Report of Safety Assessment
Coal Combustion Surface Impoundments
Georgia Power
Plant Hammond, Rome, Georgia

AMEC Project No. 3-2106-0174.0500

U.S. Environmental Protection
Agency
Office of Solid Waste and
Emergency Response
Office of Resource Conservation
and Recovery
MC: 5304P
Washington, DC 20460

December 2010

GEORGIA POWER PLANT HAMMOND, ROME GA. ASH PONDS 1-4 PIEZOMETER LOCATIONS AND MAY 2010 STABILITY ANALYSIS CROSS-SECTIONS

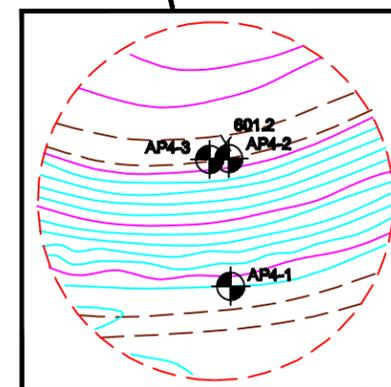
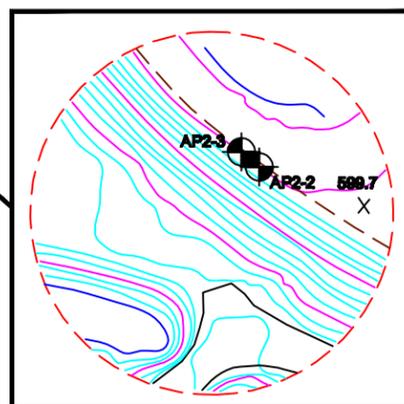
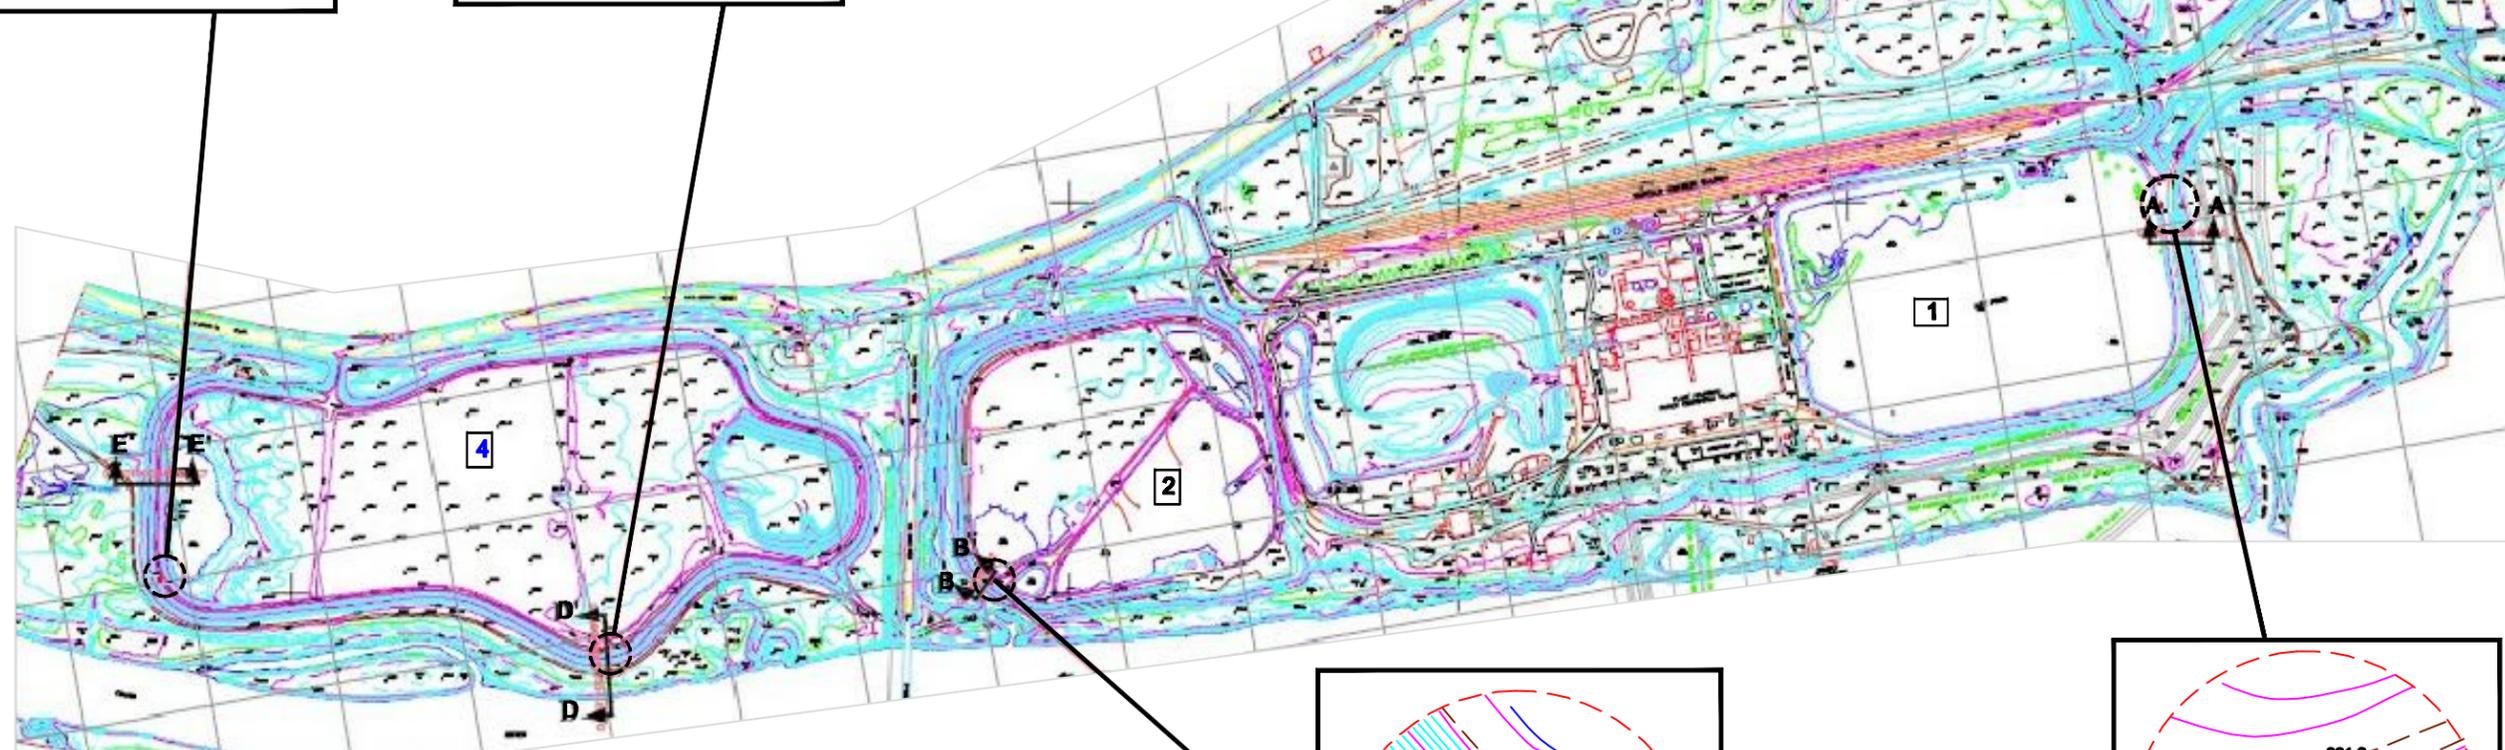
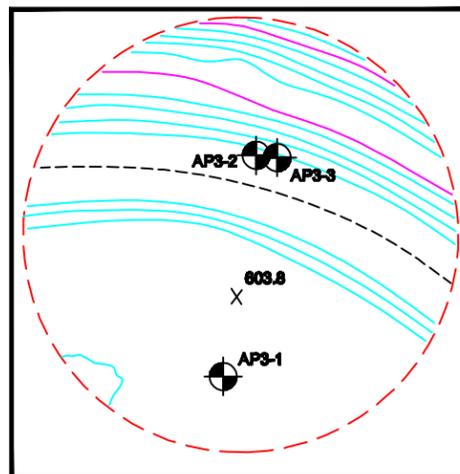
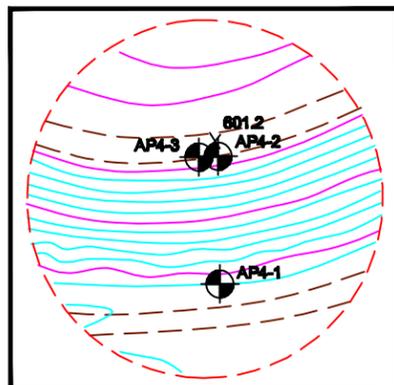
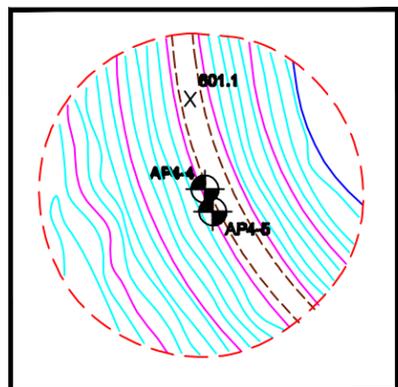
The concern with a factor of safety of 1.0 is that a failure during a seismic event could result in deposition of ash into the environment. The Georgia Power stability analysis notes that, "This number is below the required current minimum criteria, but is at the minimum criteria at the time of the design of the ash stack in the 1990s according to the criteria set in the US Corps of Engineers Manual EM 1110-2-1902, April 1970" (HAM-API 077, p. 6 of 196). However, the revised report states that closure of the stack under Georgia Solid Waste Management Rules will require the slopes to be flattened to at least 3H:1V. The revised Stability Analysis submitted for review subsequent to publication of the draft report, indicates that the 3H:1V slopes will provide an acceptable factor of safety of 1.1.

The revised Slope Stability Analyses indicate that the ash stack will meet minimum factors of safety once the ash slopes have been flattened to no steeper than 3H:1V. Furthermore, it is indicated that this will be accomplished prior to closure under Georgia Rules for Solid Waste Management, Chapter 391-3-4. Although the potential amount of dry ash released to the environment during a seismic event is likely to be minimal, AMEC recommends that flattening of the ash stack slopes be performed as soon as possible to avoid possible failure of the ash stack during a seismic event.

2-29

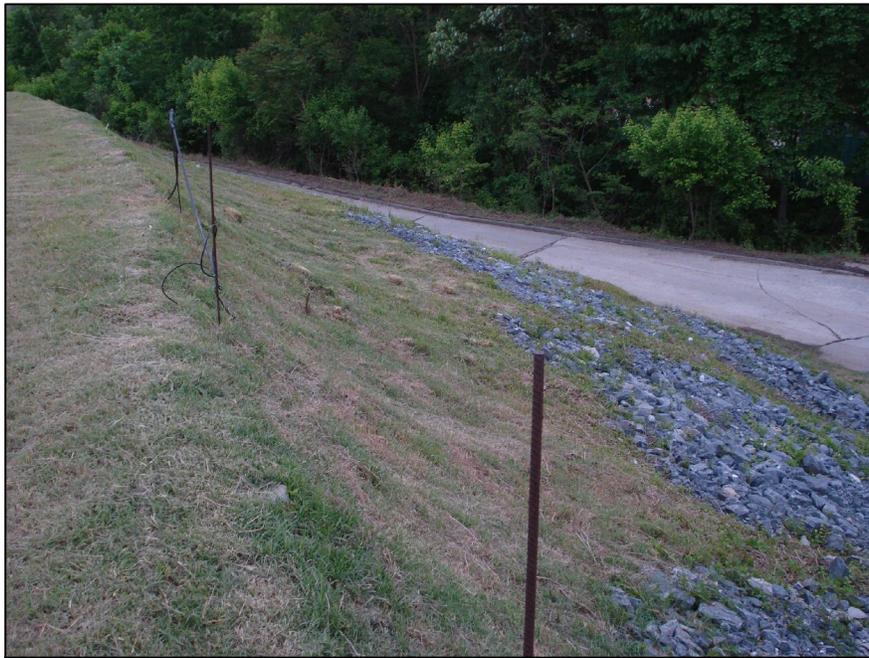
GRAVEL AREAS AND STEEP SLOPES ALONG SOUTHERN FACE

4-27

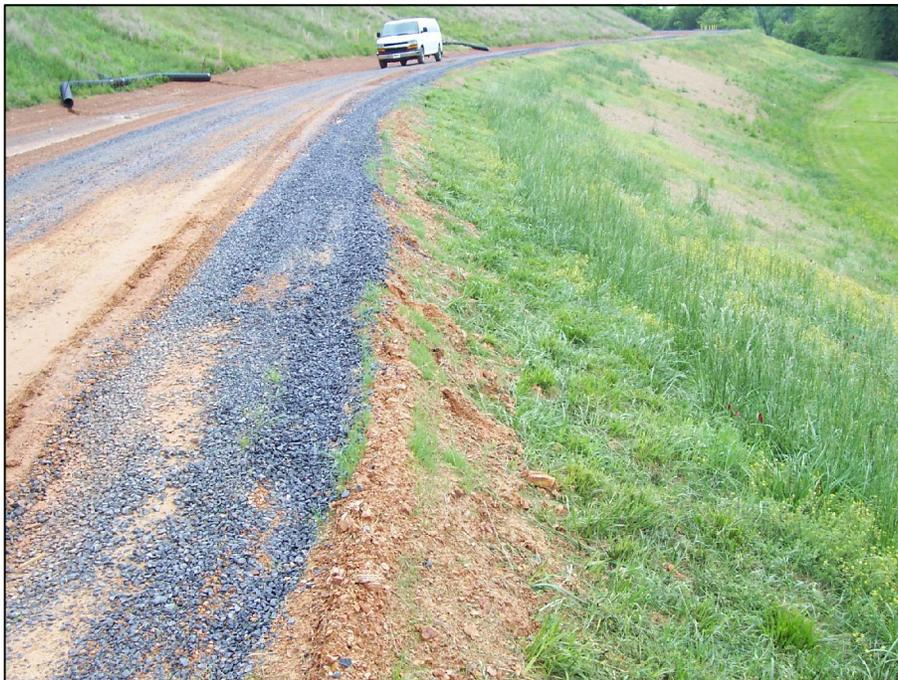
LACK OF VEGETATION ALONG SOUTHERN DOWNSTREAM SLOPE

Vegetation on the impoundments should continue to be aggressively managed. We further recommend that vegetation be managed based on guidance in (a) Corps of Engineers EM 1110-2-301, *Guidelines for Landscape Planting and Vegetation Management at Floodwalls, Levees, and Embankment Dams* and (b) FEMA 534, *Technical Manual for Dam Owners: Impacts of Plants on Earthen Dams*. Additionally, animal impact should be mitigated based on guidance in FEMA 473, *Technical Manual for Dam Owners: Impacts of Animals on Earthen Dams*.
